**CITY OF TEMPE
DEVELOPMENT REVIEW COMMISSION**

**Meeting Date: 02/26/2013
Agenda Item: 2**

ACTION: Approval for a Development Plan Review for APACHE VILLAS, located at 2148 E Apache Boulevard on 2.147 acres. The applicant is George Swarstad, Bowman Consulting.

DPR12242 Development Plan Review including site plan, building elevations, and landscape plan

Apache Apartments
north elevation

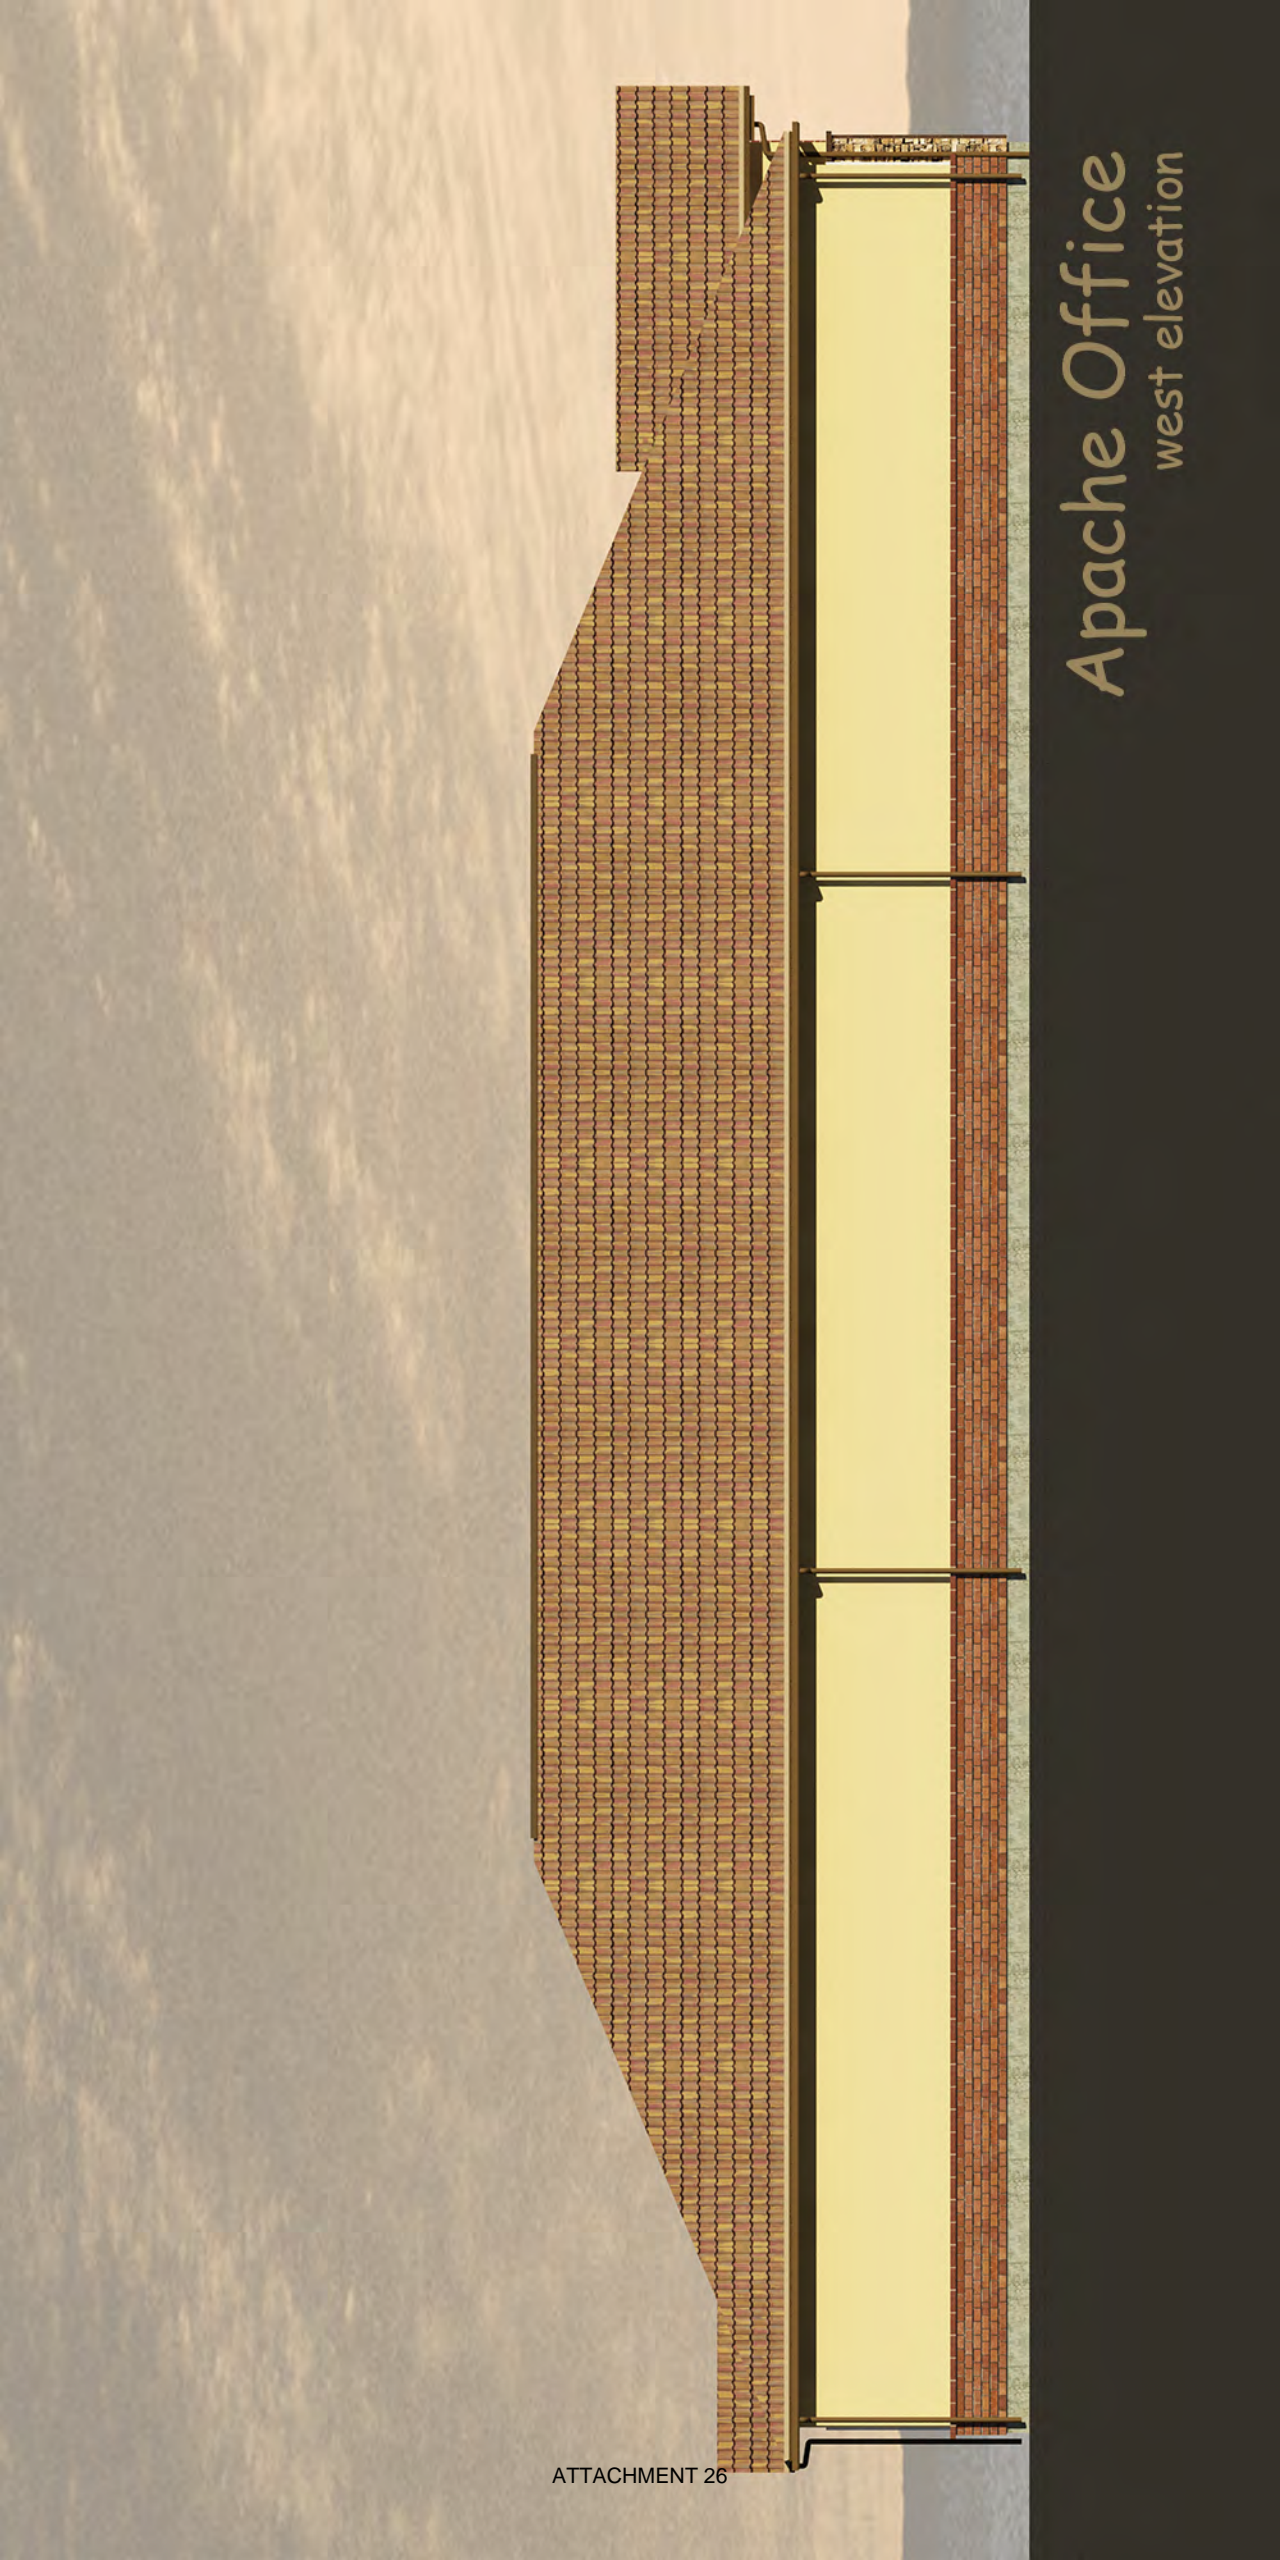
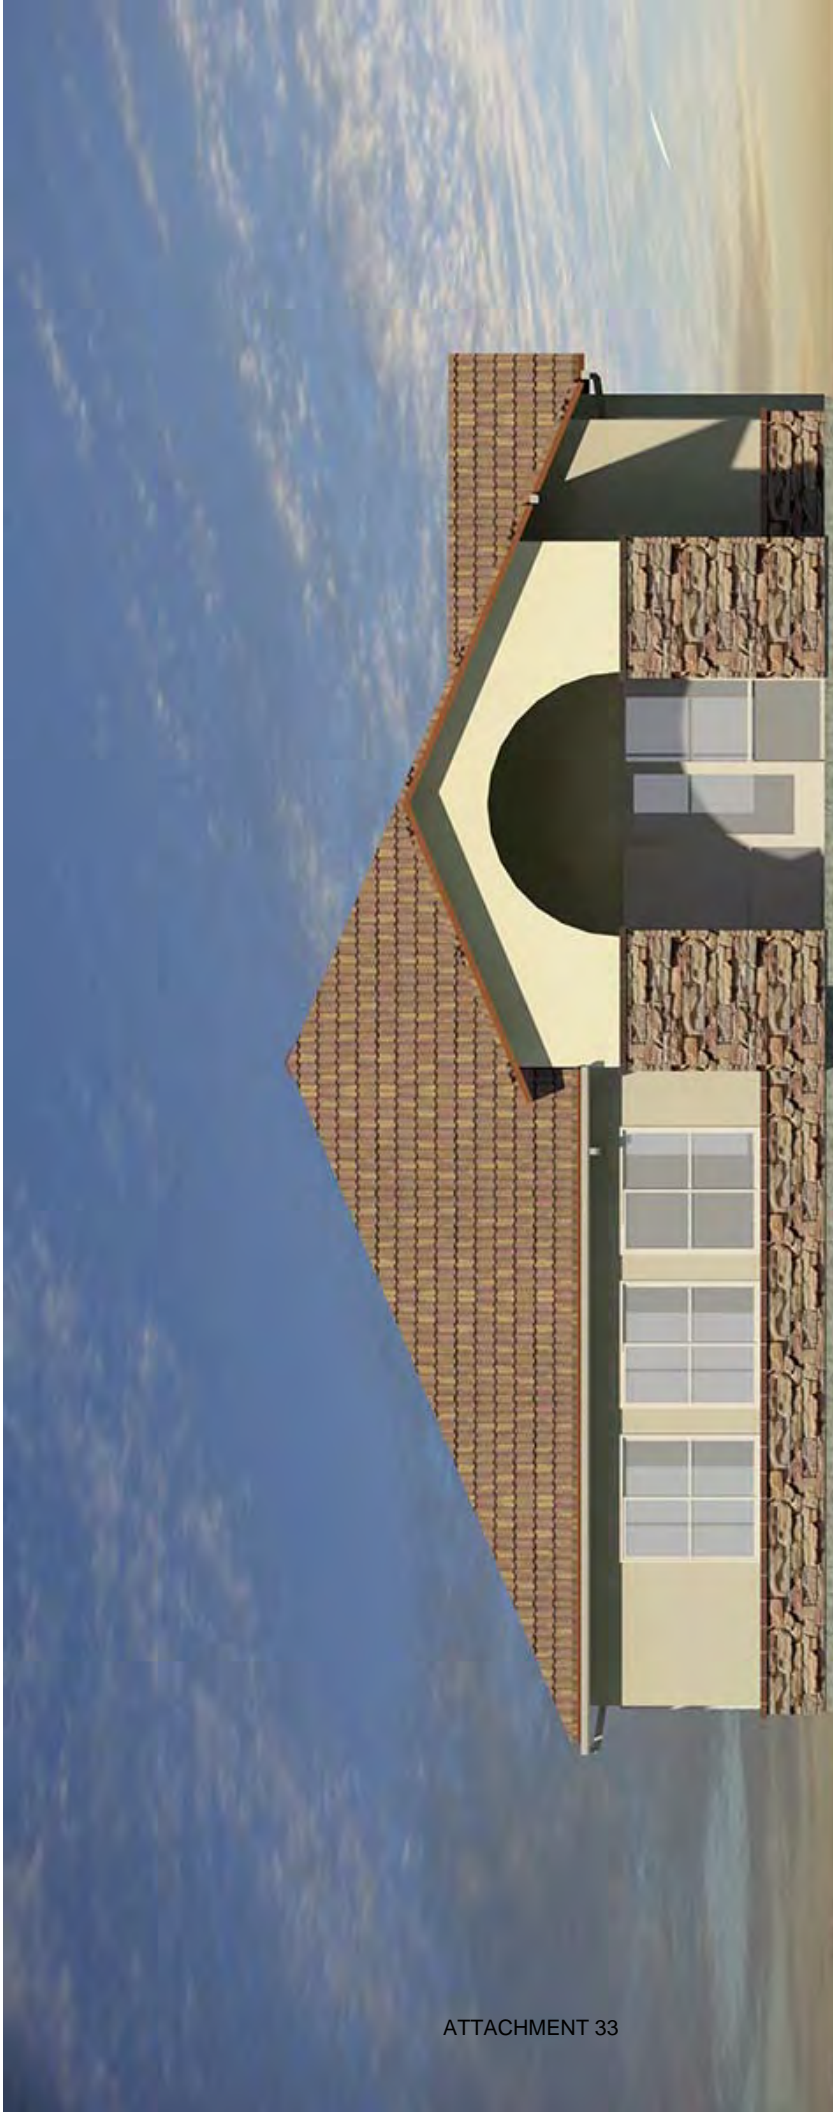
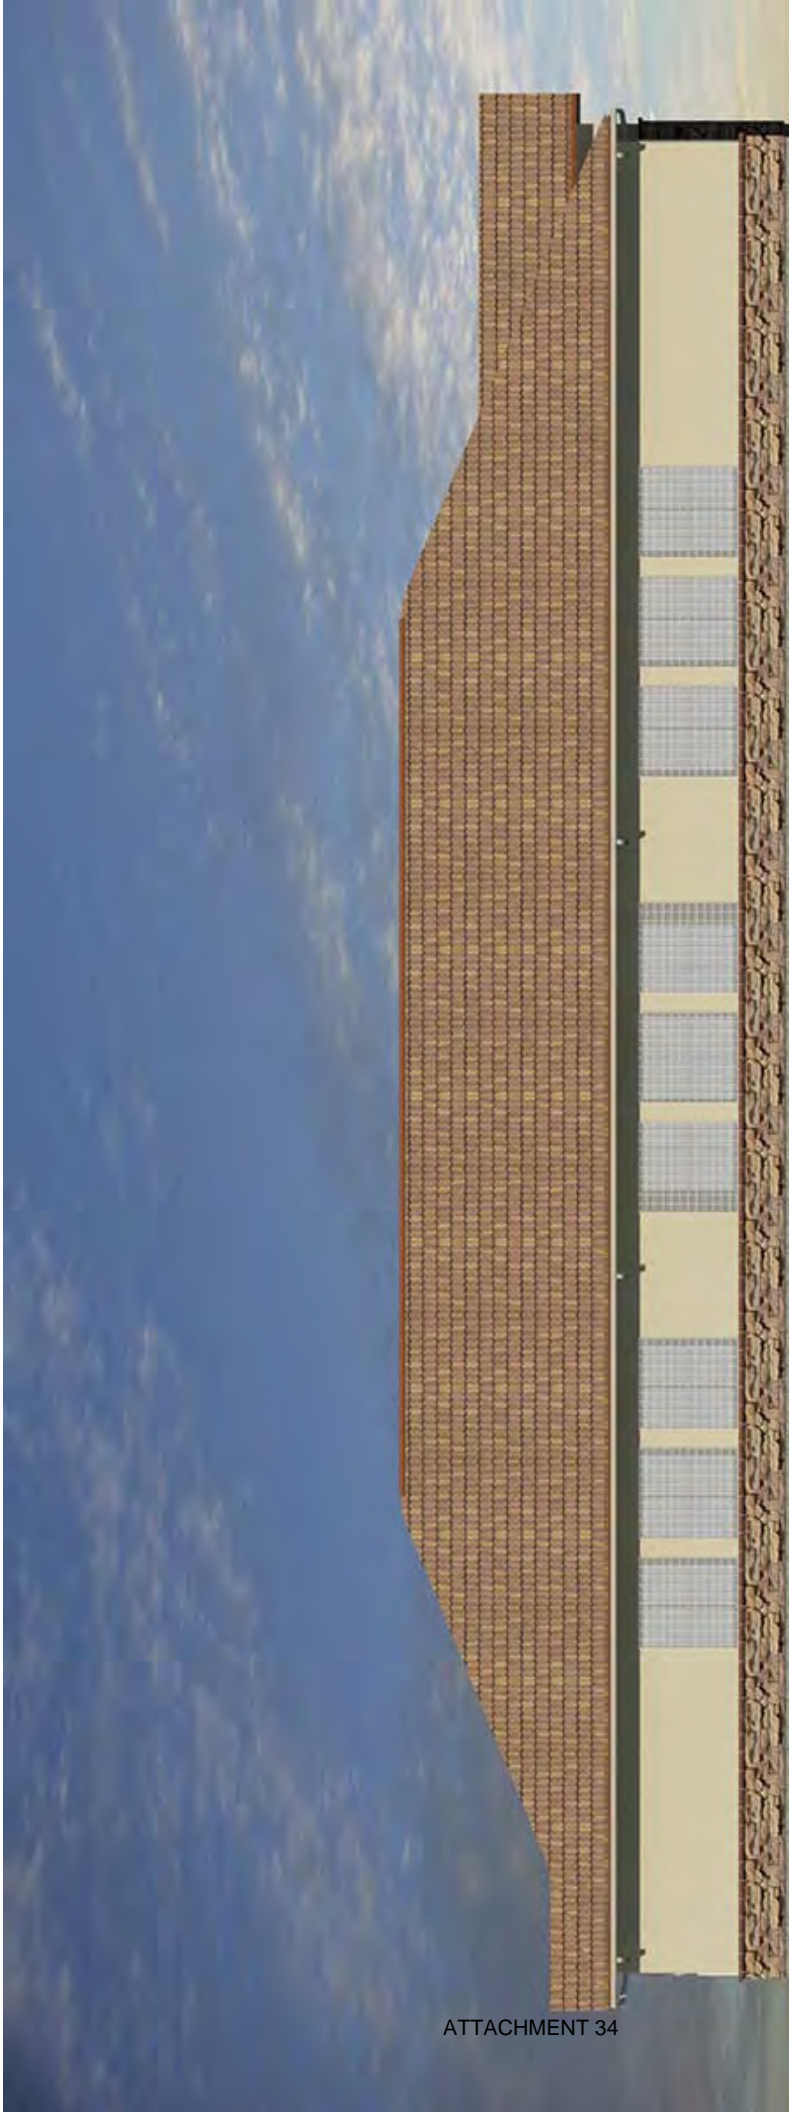
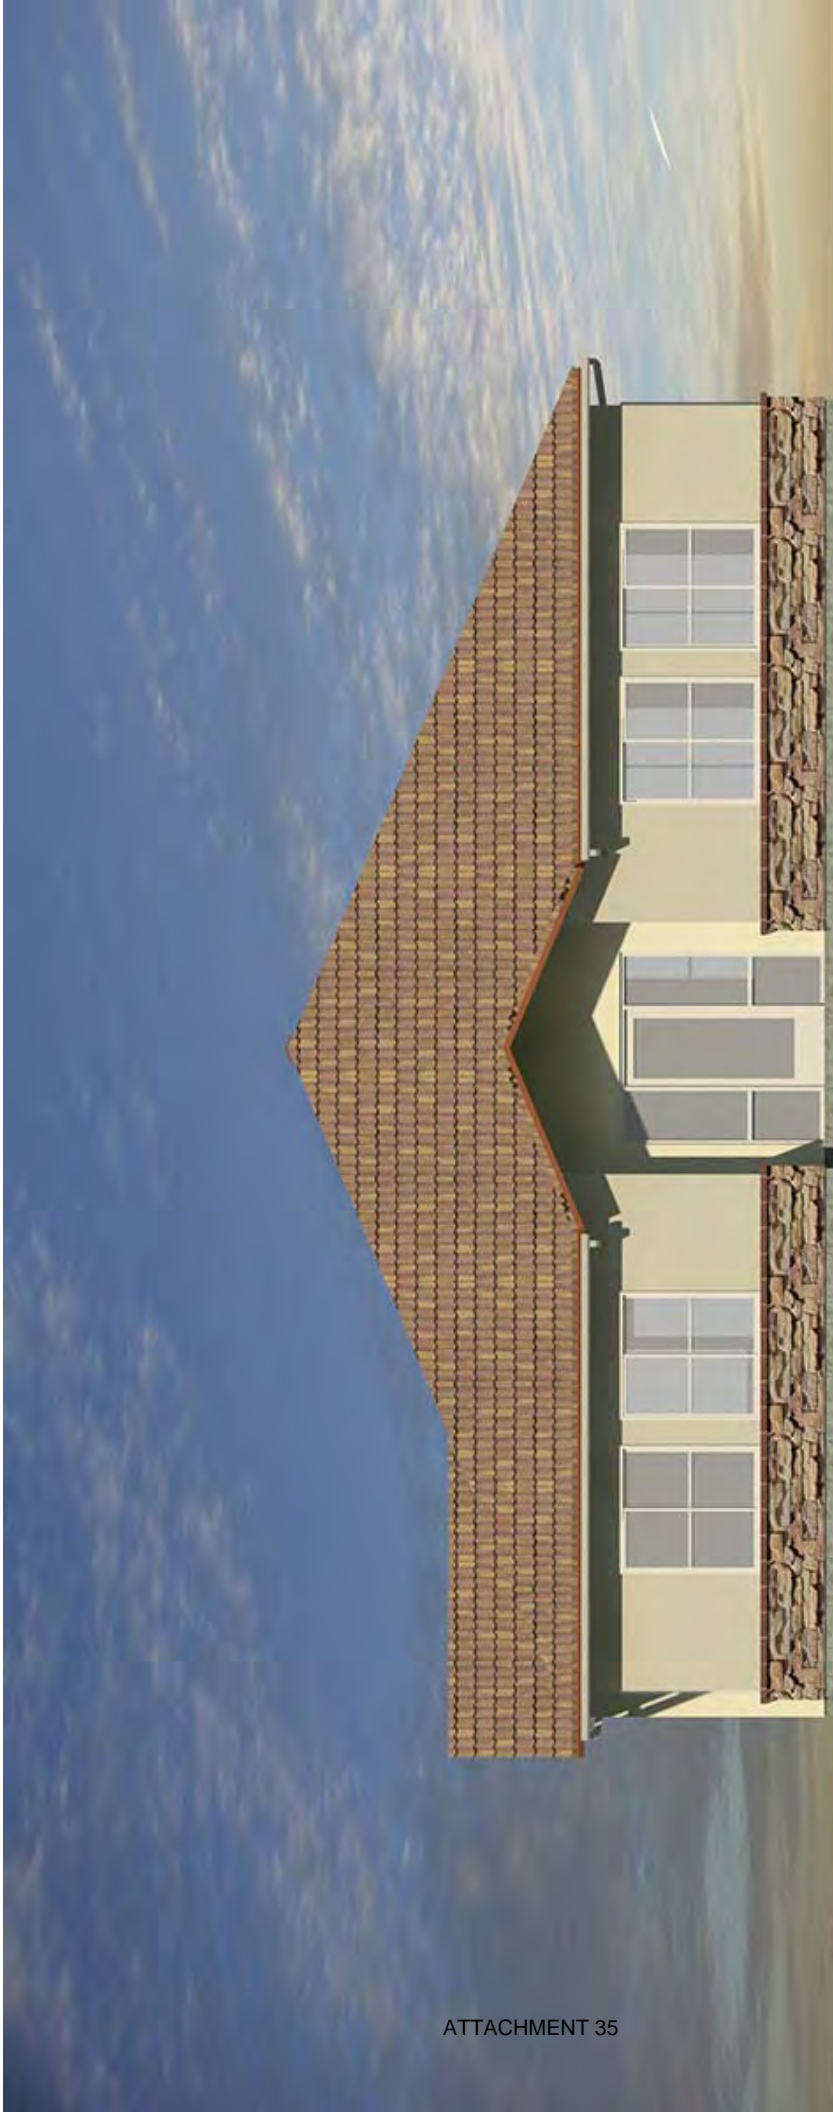
The Commission expressed concerns regarding the colors, materials and details of the building designs for the two buildings on site. Specific issues were the combined use of tile, stacked stone and red brick, and the combination and application of colors in a seemingly random pattern that did not architecturally relate to the building elements. The applicant has revised the elevations based on the input provided at the hearing. The four-story apartment community has a maximum height of 60 feet to the top of the pitched roof elements. The roof is a light mottled terra-cotta colored cement tile on a pitched gable and hip constructed truss system. The predominant roof material in this area is asphalt shingles on pitched roofs, or flat roofs with parapets on some commercial buildings. The proposed material is superior in quality to the surrounding environment, and enhances the aesthetics of the area. The elevations demonstrate four-sided architecture, with a strong defined base of stacked stone. This material provides a strong textural contrast to the smooth stucco. The applicant considered the visual abilities of the residents in selecting materials, and felt that a product with greater variation in relief would provide more interest. The wainscot wraps the building, changing elevation where the patio walls on the first floor are located, and then extending higher up to define the lower floor of the structure. The stone application ties into the architectural features; per Commission direction, the stacked stone was removed from the upper floor elements and the decorative architectural elements at the top of the gables were removed to simplify the façade. The units have large windows with recessed patios and balconies on all four elevations. This project incorporates elements that are both residential and commercial in appearance, and have been simplified in materials, colors. The vertical pop-outs and recesses provide more play with sunlight and shadows, articulating the design throughout the day. The colors were modified to be more muted and neutral, but still within the warm earth tones common in residences within the area. The overall effect of the changes updates the building to a more simplified contemporary look.

- Primary building: Stucco painted Sherwin Williams SW7033 *Sole* (light yellow)
 - Fascia & Trim: Dunn-Edwards DE6091 *Red Hook* (rust brown)
 - Wainscot: Coronado Stone Old World LedgeStone *Burnt Oak*Provide main colors and materials with a light reflectance value of 75 percent or less. Specific colors and materials exhibited on the materials sample board are approved by planning staff. Additions or modifications may be submitted for review during building plan check process.
